STAFF RECOMMENDATION 4122 Aberdeen Road June 16, 2021

Application: Violation—Outbuilding **District:** Cherokee Park Neighborhood Conservation Zoning Overlay **Council District:** 24 Base Zoning: R8 Map and Parcel Number: 10308020100 Applicant: Mark Gilliam, owner Project Lead: Melissa Baldock, melissa.baldock@nashville.gov

Description of Project: The applicant constructed an outbuilding in violation of the preservation permit. The construction included a wall dormer not included on the approved plans.

Figure 2. Front elevation approved as part of the preservation permit.

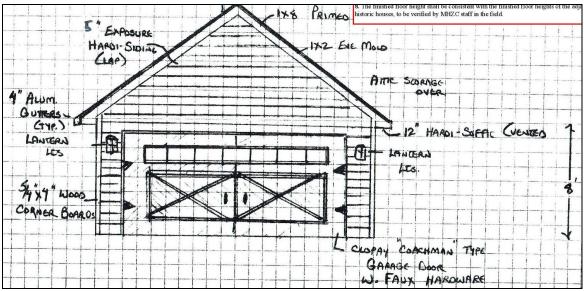
In March 2016, MHZC staff issued an administrative preservation permit for the construction of a twenty foot by twenty-two foot (20' X 22') one-story outbuilding that would not be used as a DADU. The applicant subsequently constructed a dormer on the

outbuilding which was not part of the approved plans and which did not meet the design guidelines in size and scale at that time (Figures 2-6).

Figure 3. Side elevation approved as part of the preservation permit.

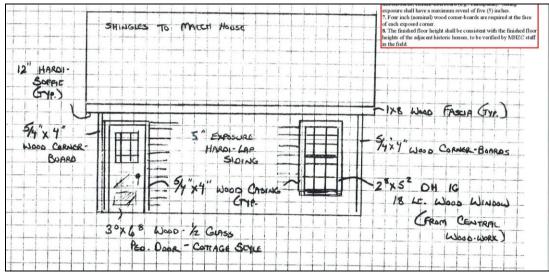
Analysis: The garage is twenty feet by twenty-two feet (20' X 22'), or four hundred and forty square feet (440 sq. ft.). The wall dormer has a width of approximately twenty-one feet (21'). The design guidelines allow for each outbuilding to have a wall dormer with a maximum width of fourteen feet (14'). This wall dormer is wider than what is allowed under the design guidelines, but staff finds that it is still appropriate because the overall height and scale of the outbuilding is much smaller than what could be built under the design guidelines.

The design guidelines would allow an outbuilding to be up to seven hundred and fifty square feet in footprint (750 sq. ft.), with a twelve foot (12') wall height, and a maximum height of twenty-five feet (25'). By comparison, this garage is four hundred and fourty square feet (440 sq. ft.), with a wall height of eight feet, six inches (8'6") and a maximum height of sixteen feet (16'). In addition, the design guidelines would allow for a second dormer, inset two feet (2') from the wall below, on the other slope of the roof, but this outbuilding just has one dormer. Because the over all height and scale of the outbuilding at 4122 Aberdeen is significantly smaller than what would be typically allowed under the design guidelines, staff finds that this dormer to be appropriate. Moreover, since the Commision's concern in not approving the dormer in 2018 was that it could make people think that wall dormers can be approved, now that wall dormers can be approved, that concern is moot.

Recommendation Summary: Staff recommends approval of the dormer, finding that it meets Section VII.B. of Part I. of the Design Guidelines for Turn of the Century Districts.
